**Title: QUALITY AUDIT**

**Road Safety Audit, Access Audit, Cycle Audit and Walking Audit.**

**Mixed Use Development at Former Blakes and Esmonde Motors Site, Stillorgan Co. Dublin.**

**Report reference: 1390R01**

Drawing 20-071 P011 Rev -Proposed Road and Building Levels, Left turn from Lower Kilmacud Road to The Hill.

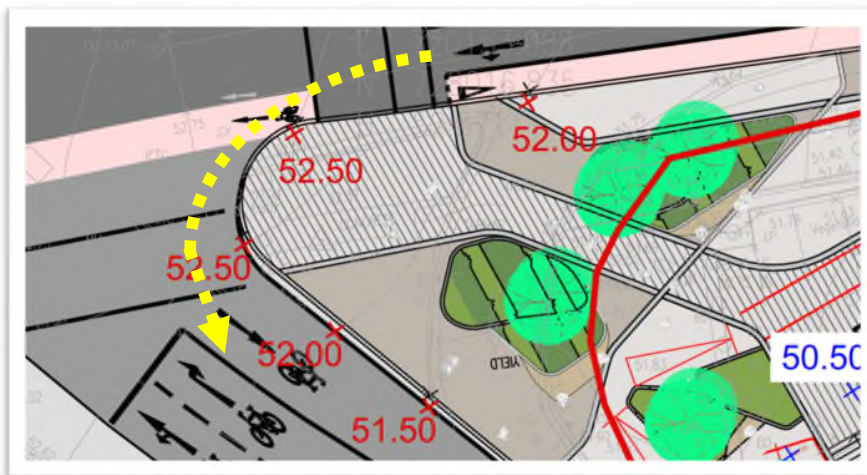
It is unclear if a heavy goods vehicle will be able to undertake the acute left turn from Lower Kilmacud Road to The Hill without entering the right turning lane or crossing the stop line. If this manoeuvre cannot take place this could lead to sudden braking and rear-end collisions.

It is recommended that a swept path analysis be carried out to ensure that the manoeuvre can be easily undertaken. If necessary, the stop line on The Hill should be set back.

3.4	Yes	Yes	Please see attached Waterman Moylan Drawing No. 20-071-P176	Yes

as required, this indicates how HGV's can maneuver turn	
3.5	Yes	Yes	We can confirm solid build out footpath will be in place rather than hatch line marking, see attached updated drawing no. 20-071-P111 which indicates same.	Yes

Drawing 20-071 P011 Rev -Proposed Road and Building Levels, The Hill.

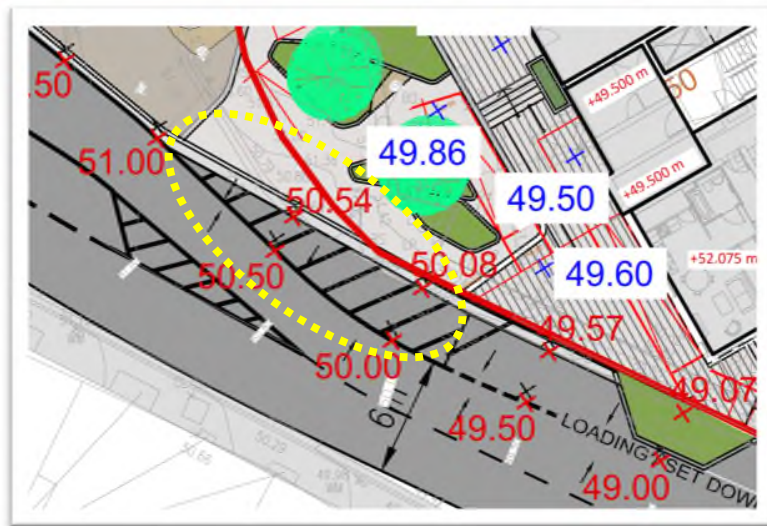
There is a risk that the hatched area in advance of the loading bays/set-down area on The Hill will be used as a parking area for those using the retail units on the opposite side of the development. This could lead side-swipe collisions of passing vehicles.

It is recommended that a solid buildout be provided to avoid parking and to help define the road layout for drivers.

Drawing 20-071 P012 Rev -Proposed Road and Building Levels, The Hill.

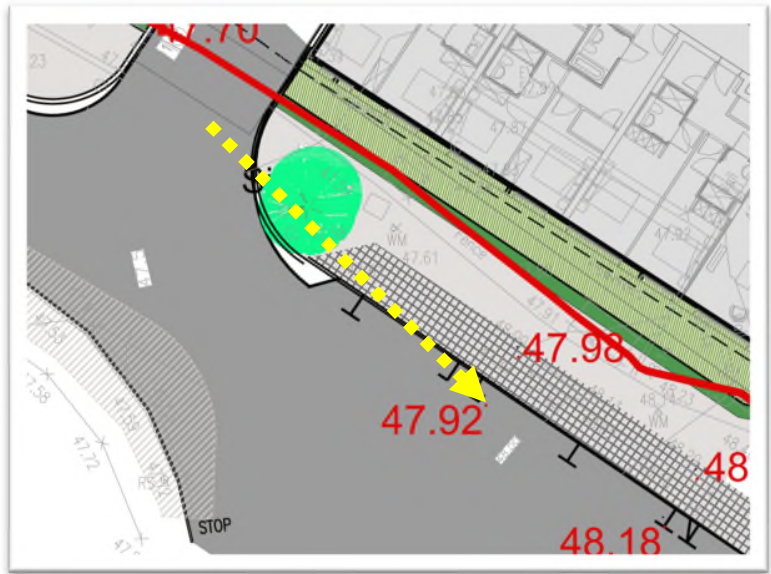
There are 4 no. car parking spaces to the south east of the south basement access on The Hill. Vehicles parked in these spaces may block a drivers visibility to their left as they exit the basement.

It is recommended that the spaces be provided outside the visibility splay.

3.6	Yes	Yes	see attached drawing no. 20-071-P180 which indicates sightlines at this area as required.	Yes
3.7	Yes	Yes	see attached drawing no. 20-071-P185 which indicates signage at this area as required.	Yes

Drawing 20-071 P012 Rev -Proposed Road and Building Levels, The Hill.

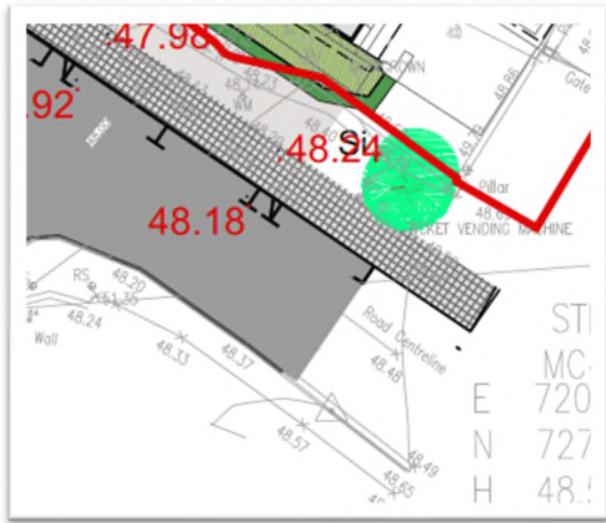
There is a risk that visitors driving to the development, unfamiliar with the area, may not realise that they cannot continue south on The Hill beyond the Glenalbyn Road junction as it is primarily a one way road except for Gardaí. A lack of warning could lead to drivers travelling south resulting in side-swipe collisions with northbound vehicles or in extreme circumstances wrong way driving on the N11 dual carriageway.

It is recommended that additional warning signage and road markings be provided at the Glengalbyn Road junction so that drivers do not travel beyond the junction and do not have to U-turn.

Drawing 20-071 P023 Rev -Proposed Basement Drainage Layout, Southern Basement.

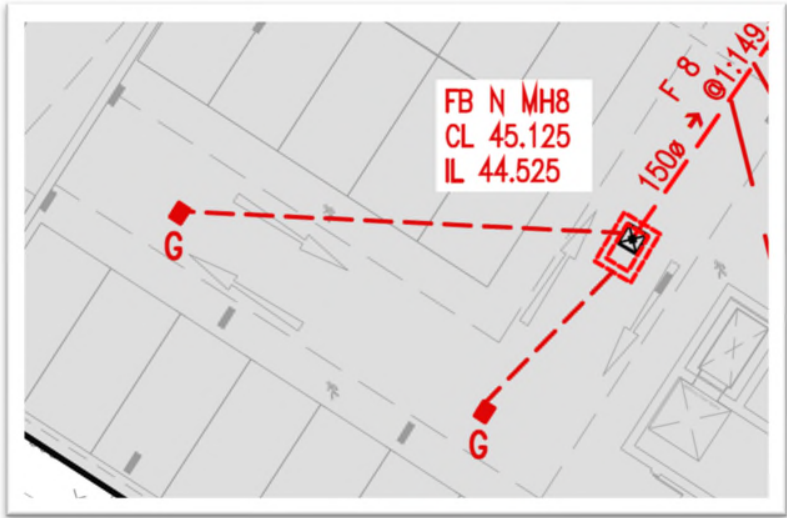
There is a section of the southern basement which has to take two way traffic. It is unclear if there will be sufficient room for two way traffic and pedestrians given the narrow lane width and the presence of structural columns. This could lead to material damage collisions.

It is recommended that the layout be modified if insufficient space is available for two way traffic. It is assumed that column locations are drafting errors at this location and elsewhere within the basements.

3.8	Yes	Yes	We can confirm column location were a drafting area and are located off the carriageway, the operation speed of vehicles within the basement are expected to be below 10kmph, due to low operation speeds and irregular vehicles movements, circa 2 per day max, that there is sufficient space for vehicles and pedestrians	Yes

Drawing 20-071 P023 Rev -Proposed Basement Drainage Layout, Southern Basement.

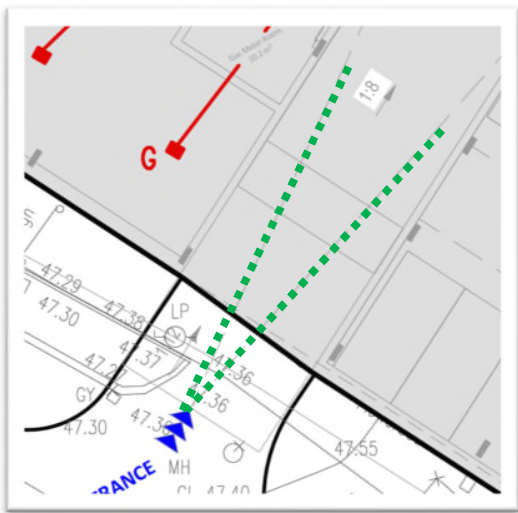
The 1:8 ramp into the southern basement extends into the footpath along The Hill. A steep crossfall on the footpath could lead to falls for the nobility impaired.

It is recommended that the ramp terminates at the rear of the footpath and that normal footpath crossfalls only are provided.

3.9	Yes	Yes	Levels where the footpath crosses the road have now been updated and the crossfall at crossing point is now 1:50, see attached updated drawing no. 20-071-P112 as required	Yes
